1 **GUAM CONSOLIDATED COMMISSION ON UTILITIES**

2 **RESOLUTION NO. 49-FY2016**

3 **RELATIVE TO APPROVAL OF CHANGE ORDER NO. 3 FOR**
4 **THE CENTRAL GUAM RESERVOIRS DESIGN PROJECT**

**RE: Change Proposal 06 for PW12-04 Design Services for GWA's Central Water Reservoirs, GWA Project W14-006-BND
Additional Design Services for Chaot No. 2 Reservoir, PRV Improvements, SCADA Improvements, and Hyundai Pump Station**

**WELL A-12
FIGURE 7**

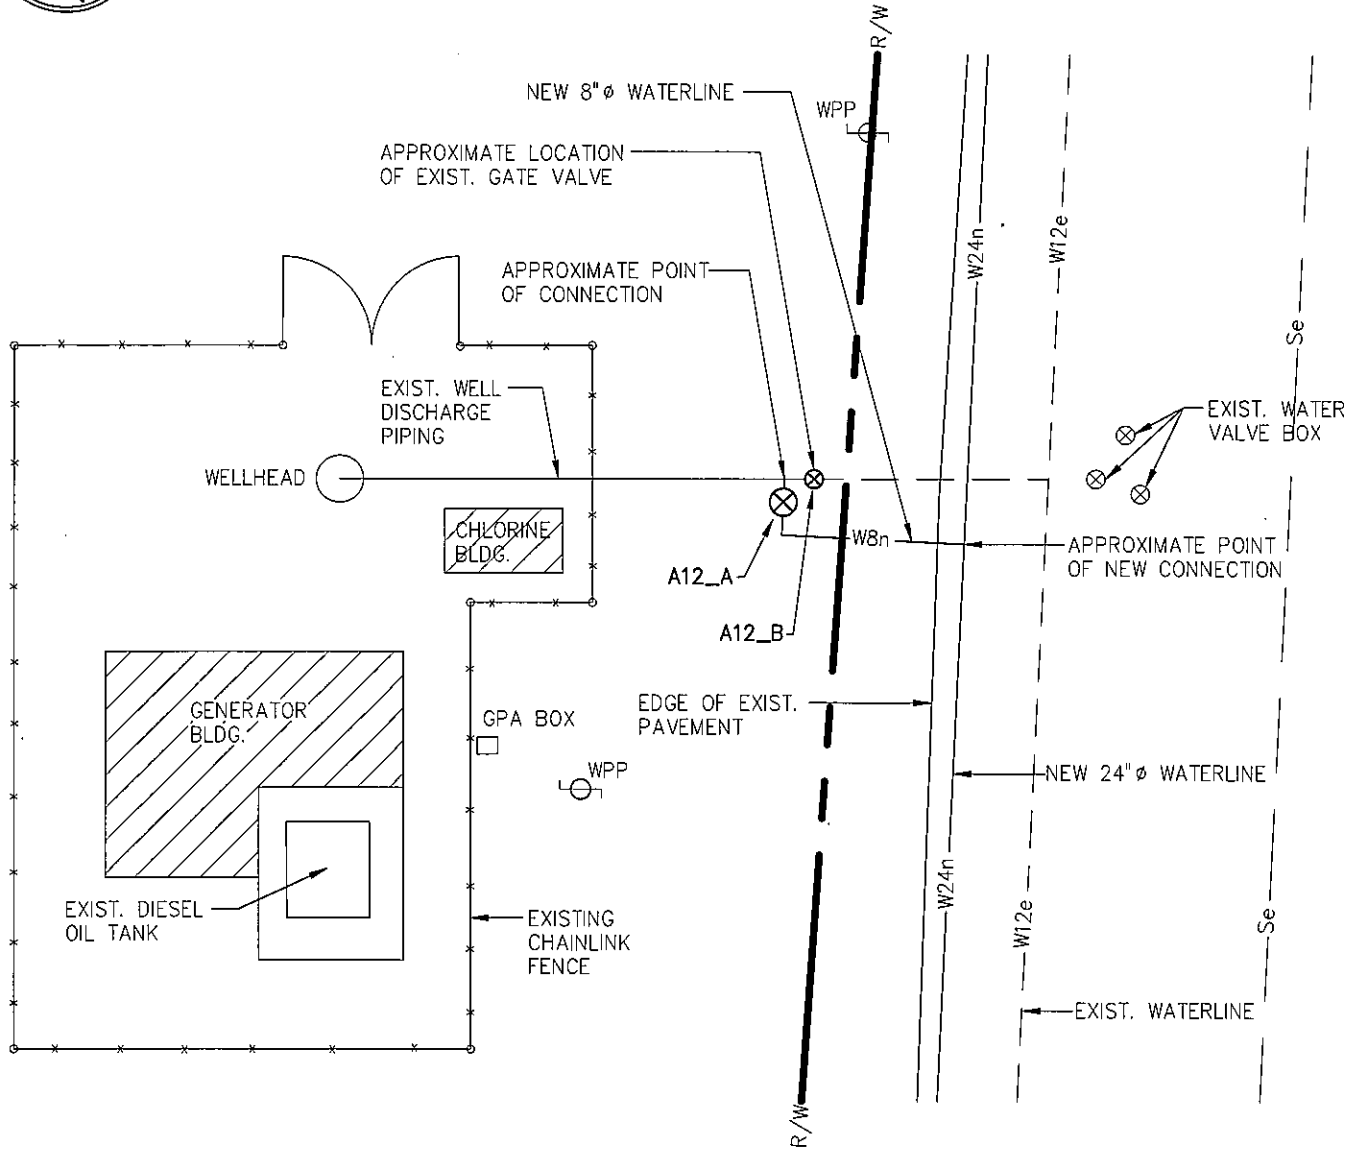
Task B – PRV and Vault and Route 4 Valve Replacement: GHD shall include the design for the replacement of the Pressure Reducing Valve (PRV) near well A-12 in the Chaot No. 2 Reservoir construction documents. The existing PRV is not operating and must be replaced. The valve has no bypass, and there is evidence of a pipe break adjacent to the vault. Plans will be developed to show replacement of the PRV, the addition of a bypass with smaller PRV, and a new vault large enough to house the valves and bypass. Waterlines on each side of the existing vault will be replaced as required to repair expected pipe breaks or leakage. The design of this improvement was not included in GHD's original scope of work.
